**Clarifications to Bidder's Queries**

**Delhi Water Supply Improvement Investment Program-Tranche-1 (ADB-47176-IND),  
Delhi Jal Board**

CROSS SECTIONAL EXCAVATION DETAIL OF DI PIPELINES

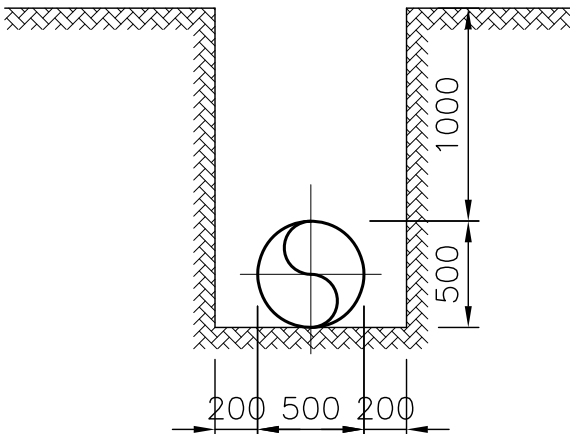
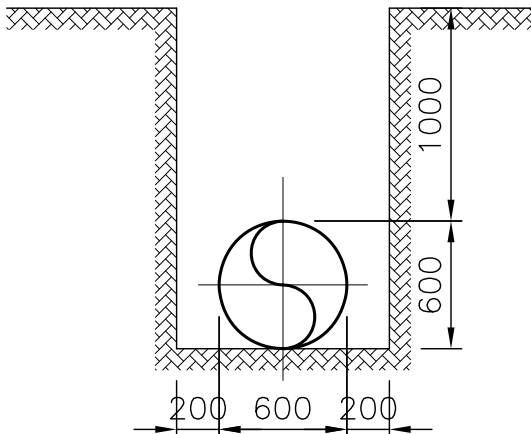
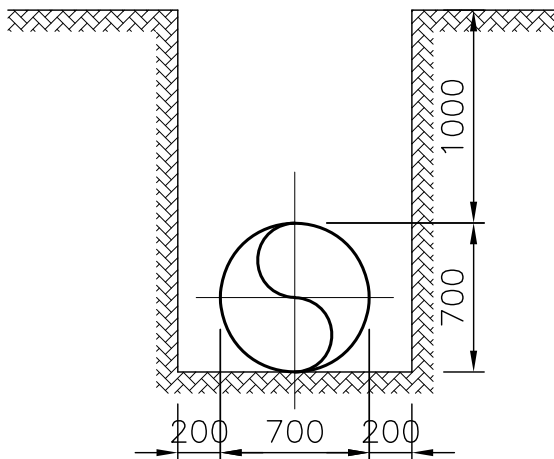
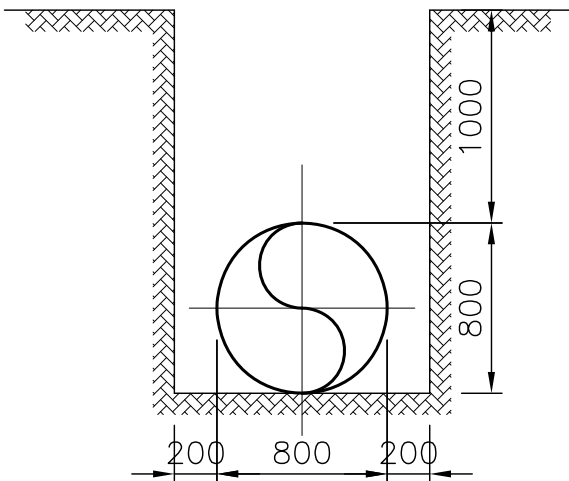
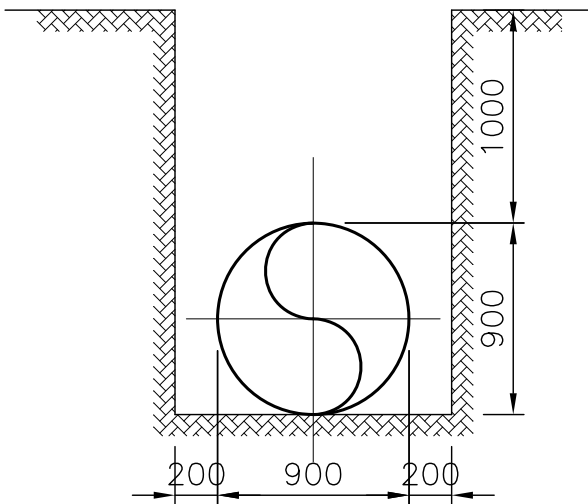
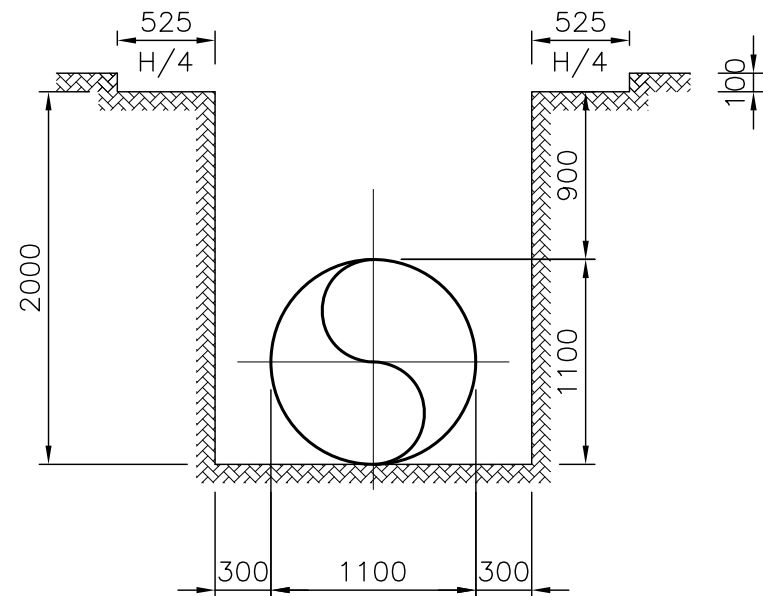
73.	Volume 4	GEN/15	-	Pipe Trench details In general, total depth of excavation for laying pipe shall be pipe diameter plus top cover (depth between Ground level and crown of pipe) varies from 0.9 or 1 m. While, the drawing provided for depth of trench detail seems to be on the higher side (3.5m). Hence, in order to have parity among bidders, we request you to provide the revised depth of top cover to be considered. Kindly consider and issue necessary amendment.	Refer C&A (Corrigendum & Addendum) No.3 S.No.25-(1).

KEY SLD FOR CLEAR WATER PUMPING STATION 120MGD WTP AT WAZIRABAD (PROPOSED)

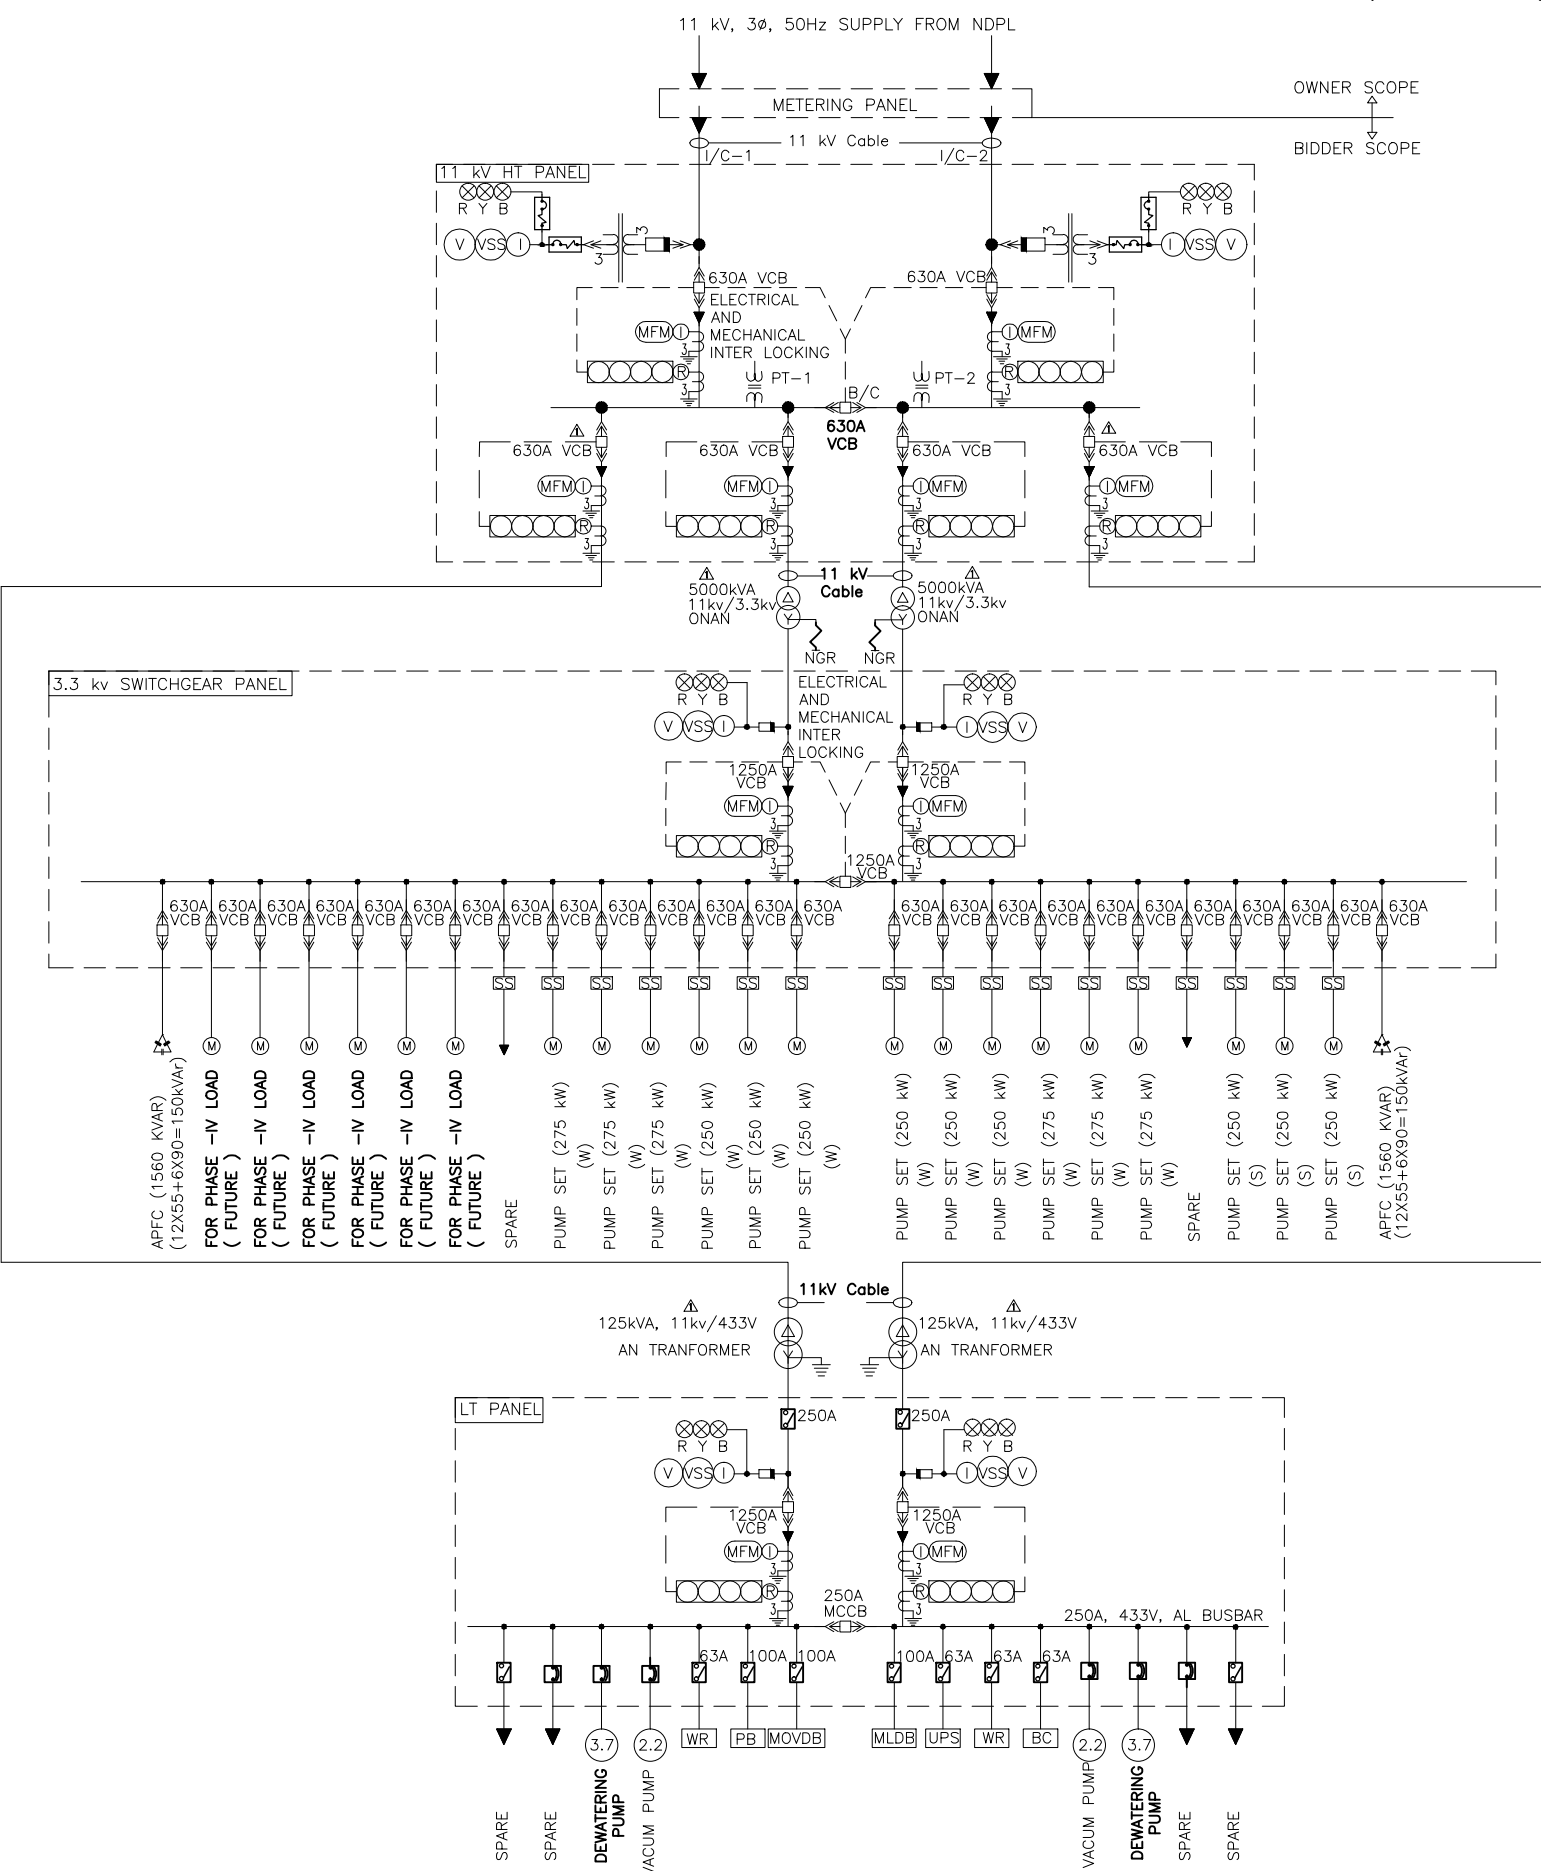
108.	Vol - 1 & Vol - 4 & Vol - 6	Table 6.11: Details of Proposed Electrical Components & Item No:3.0 HT & LT Transformers	4-30 & 56 of 69	<p>Transformer rating</p> <p>As per the referred clause in Vol-1 and As per SLD (DJB/PMC/DWSIIP/04/BID/TM/ELE/18) <i>"6300kVA, 11/3.3kV ONAN Transformer has been specified"</i> Whereas as referred from Item rate BOQ <i>"5000kVA, 11/3.3kV ONAN Transformer has been specified"</i>.</p> <p>Kindly clarify.</p>	Refer C&A (Corrigendum & Addendum) No.3 S.No.25-(1).
